Comment Letter A11—Santa Clara Valley Water District, Sue A. Tippets, P.E., CFM (letter dated November 23, 2015)

Subject: City Place Santa Clara Draft Environmental Impact Report

Comment Letter A12a—Santa Clara Valley Transportation Authority, Nuria Fernandez (letter dated November 23, 2015)

Comment Letter A12b—Santa Clara Valley Transportation Authority, Melissa Cerezo and Robert Swierk (letter dated November 23, 2015)

Figures 2.23: Pedestrian Realm for Community Streets

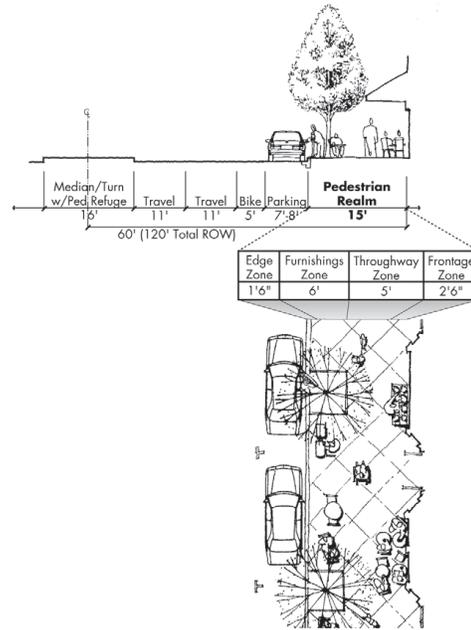
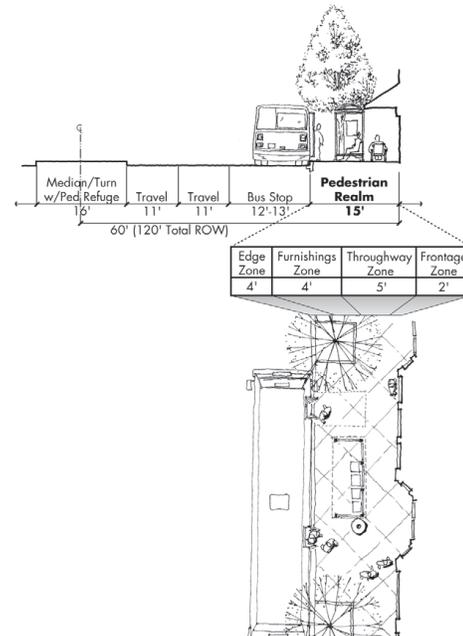
VTA’s Pedestrian Technical Guidelines (PTG), part of the implementation framework of the VTA Community Design and Transportation (CDT) Program, provide recommended typologies for various street types. For Community Streets (Arterials), the PTG recommends a minimum total width of the pedestrian realm of 15 feet to account for wide sidewalks, a buffer strip between pedestrians and automobiles with landscaping elements such as closely planted trees, shrubs, or light posts, and appropriate transition zones between the street, pedestrians and buildings (see attached *Exhibit B*). As noted above, resources on pedestrian quality of service indicate that such accommodations improve pedestrian perceptions of comfort and safety on a roadway. VTA recommends that the City require the Project Developer to provide sidewalks consistent with VTA PTG recommendations on the Project’s arterial road frontages.

A12b.15 *The commenter requests additional information about the sidewalk widths and conducting a quantitative multimodal analysis. The Project's bicycle and pedestrian impacts were addressed by evaluating the Project's effects on existing and planned facilities. The commenter's focus is on the quality of the pedestrian facilities. Please refer to Master Response regarding the development of a Deficiency Plan/Multimodal Improvement Plan (Master Response 3), which would include a review of the quality of the pedestrian and bicycle facilities and identify improvements as off-setting mitigation measures. Furthermore, the Master Community Plan*
